## Blount County Planning Department

### MEMORANDUM

SUBJECT: Staff reports on items to be added for the Thursday August 26th, 2010 regular meeting. 5:30 Hearings

- A. Concept Plans: None
- B. Preliminary Plats – Major Subdivisions:
  - 1. **Parks Ferry Cove on Fort Loudoun Lake by Charles Jones and Holly Scarlett off of Parks Ferry Road. 36 lots served by a new county road section, common driveways and the existing county road.**

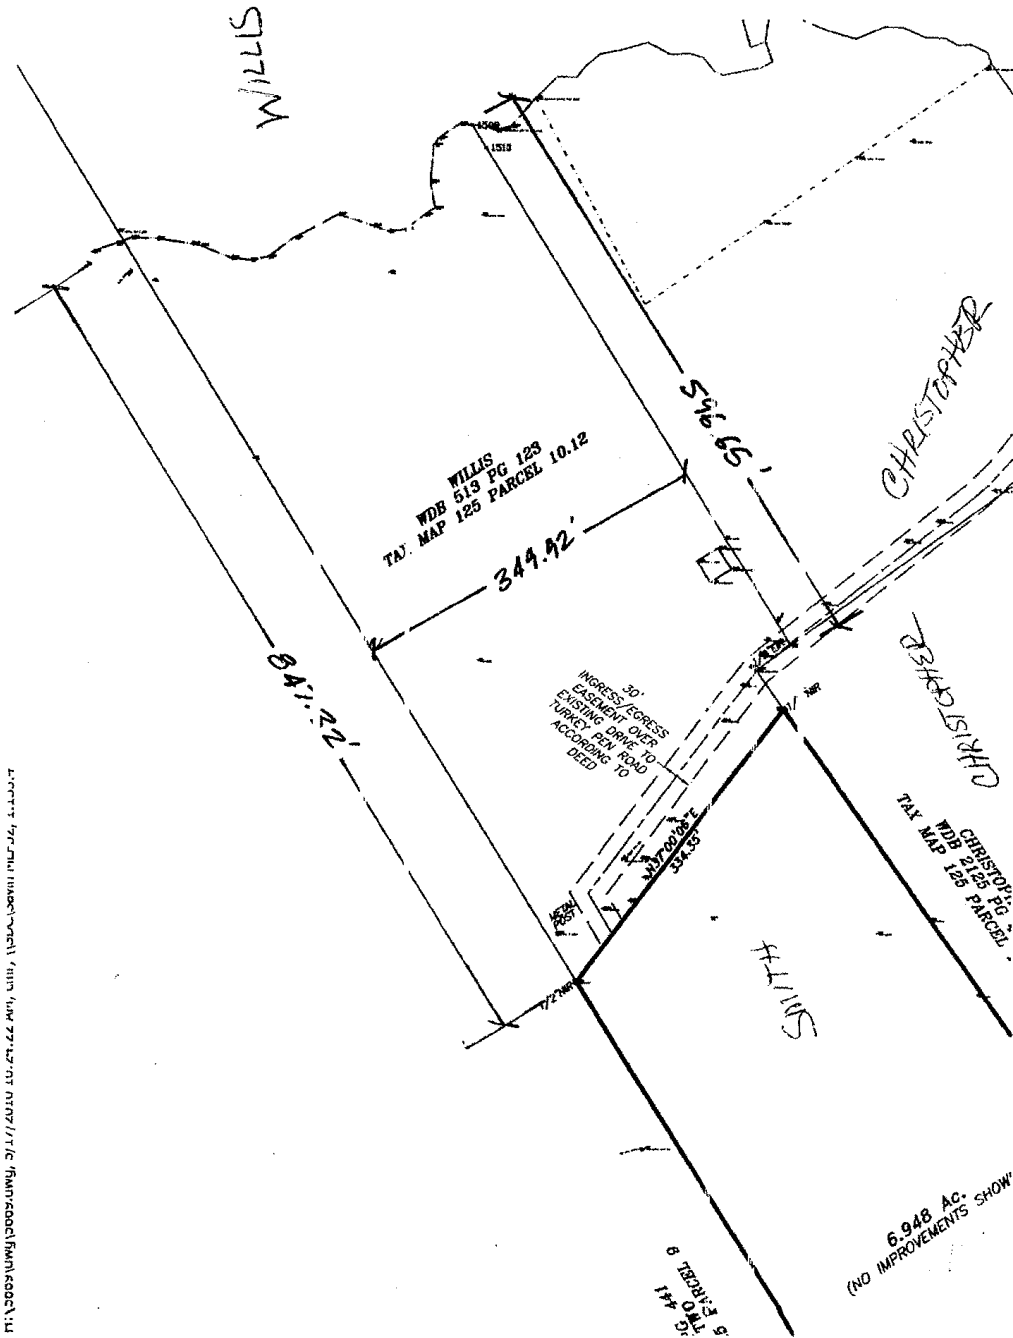
See map below for reference to parcels. Cecil Willis, et al, owns a tract off of Turkey Pen Road (Parcel 10.12). The tax map shows the property as being 14.6 acres. However, preliminary field survey measurement shows the property to have only about 9.8 acres.

Tammy and James Smith entered into contract for deed for approximately six acres (5.58 acres based on preliminary field survey information) off of the property of Willis along a pre-existing 30 foot wide easement of access. Willis would own about 8.6 acres after transfer of property to Smith if the tax maps are referenced, but less than five acres based on preliminary field survey information .

If the transfer would result in both parcels after the division being five acres or greater, the transfer to Smith would be exempt, being a transfer of greater than five acres without need of extension of roads or utilities, with remainder also greater than five acres. The preliminary field survey information calls this situation into question, and staff advised that a certification that the division was exempt could not be executed and a standard plat would be necessary.

Staff found that Willis recently transferred property less than five acres in 2008 without required plat (1.4 acres, - Willis, et al, to Hawn - Parcel 10.15 by quit claim deed registered in book 2183 page 1342). This was a violation of both State statutes and our subdivision regulations. Staff thus advised the Smiths that staff would not sign any documents related to the division of the land by Willis until the violation was rectified. The violation could be rectified if Willis would recombine the 1.4 acres into the original tract, or submit a plat for the 1.4 acres and gain approval of the lot. The Smiths reported that Willis could not arrange the recombination, and that the platting of the lot was outside their control.

The Smiths request approval of a plat for the proposed approximately 6 acre tract without any other requirements. See transcribed letter attached. Staff notes the violation of our subdivision regulations and requests guidance on further legal action the Planning Commission may wish to take in regards to the Willis 1.4 acre division. Staff also notes that approval of the Smith request would imply a remainder less than five acres and an unplatted lot that is usually required to be shown and approved on a plat.
